**Structural Inspection and
O&M, Occupational and Public Safety Review
of the
Hot Springs Tunnel System,
Hot Springs National Park
Hot Springs, Arkansas**

August, 1993

Bureau of Reclamation
Denver Office

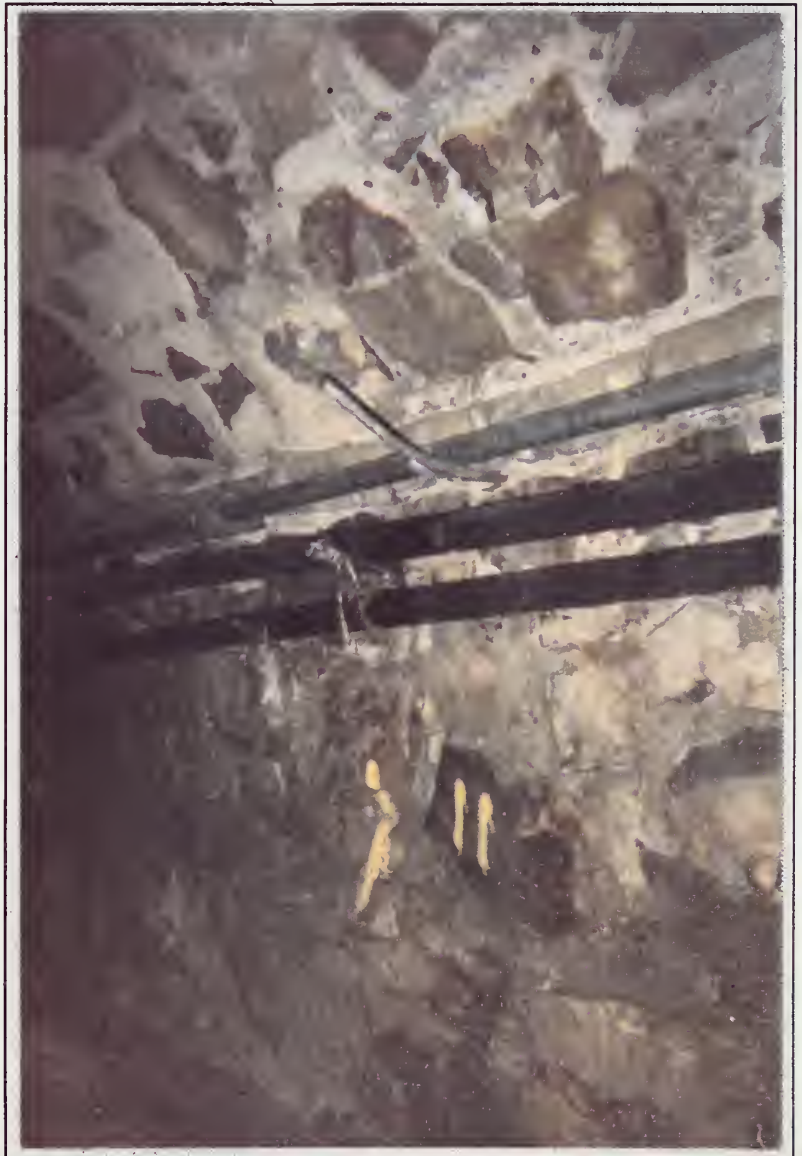
The morning of August 3, those inspecting the tunnel entered the Arch Creek Tunnel at the outlet (about Station 183+00 on Figure 2.3). Photo 3.1 shows the headwall of the outlet.

In the outlet reach the Arch sidewalls are founded on a shale rock unit. Significant undermining of the sidewalls was noted in this reach. Photos 3.2 and 3.3 show erosion at the base of the sidewalls and in the invert of the tunnel.

3.2 Sidewall of the Tunnel. The base of the sidewall has been severely undercut. The concrete traces the base of a previous repair. (About Sta. 187+00.)

3.3 Pedestal and Erosion of the Tunnel Invert (About Sta. 190+00)

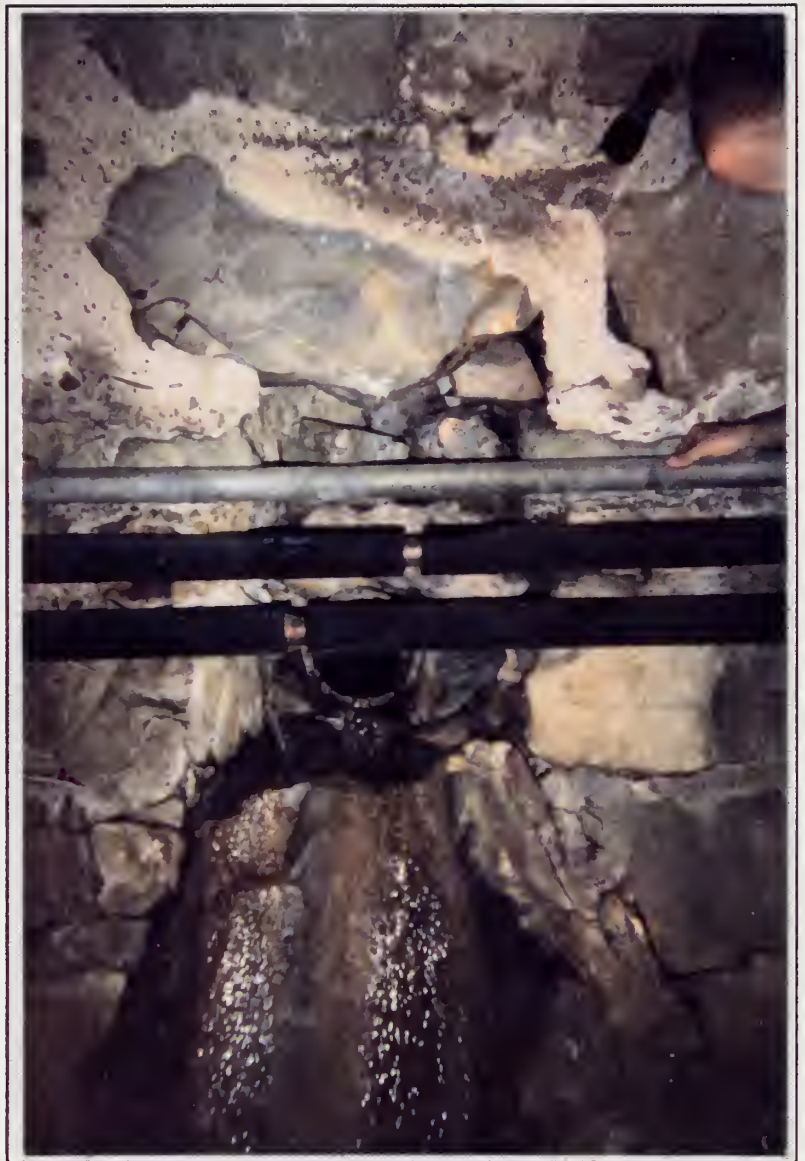
In general the arch appeared to be in good condition loose rock blocks were observed in the sidewalls where the foundation had been undermined, however; the arch and sidewalls usually appeared to be well cemented without loose blocks. Photo 3.4 shows the arch and sidewall of the tunnel. The painted number on the sidewall may be related to a recent Corps of Engineers survey in the tunnel.

Throughout the tunnel openings in the arch and sidewalls are evident. Photo 3.5 shows a pipe entering the tunnel with water flowing down the sidewall of the tunnel. Photo 3.6 shows a wooden blockout in the crown of the tunnel.

The shotcrete coating on the arch has eroded in many places through the tunnel. Photo 3.10 shows the deterioration of the shotcrete coating.

Photos 3.11 and 3.12 were taken from the surface after we exited the tunnel. The area is one of immediate concern. After we observed a somewhat haphazard arrangement of structural steel beams and pipe bracing in the tunnel, we inspected the surface to find the remains of an old structure with unprotected openings to the tunnel. The concrete structure was a thin slab supported by the steel beams we observed in the tunnel. It appeared that vehicles could park on the slab. We discussed the apparent danger with the city representative Dave Stanage on the spot. Structural modifications to this area are needed.

3.11 Vault near Arbor and Loadstone Streets. (About Sta. 238+00)

3.12 Vault near Arbor and Loadstone. Unprotected opening and slab thickness are shown.

3.13 Erosion of the Base of the Sidewalls of the Tunnel.
Erosion of previously placed concrete is visible.
(About Sta. 240+00)

1993-T1-1. Fence the vault area near the intersection of Loadstone and Arbor streets and cover openings to the tunnel.

A serious safety problem is evident at the vault near Loadstone and Arbor Streets. The area should be fenced to prevent access and structural repair work should proceed.
